## Reply by Author to T. C. Tai

EARLL M. MURMAN\*

## Errata

### Structure of Shock Waves in Cylindrical Ducts

Fig. 9 Correlation of experimental data.

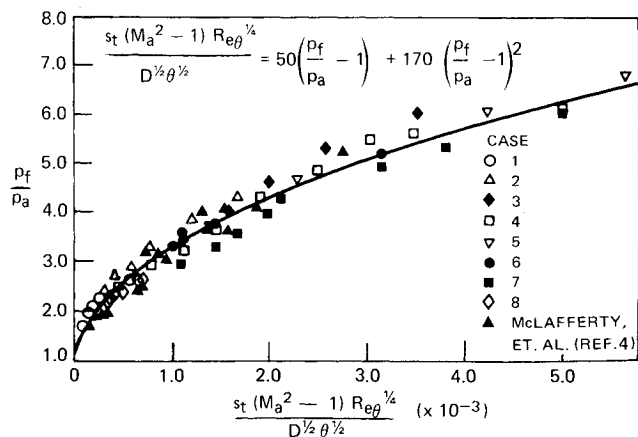
**T**HE open circles in the upper part of Fig. 9 should be solid diamond symbols corresponding to case 3. The revised Fig. 9 is presented below.
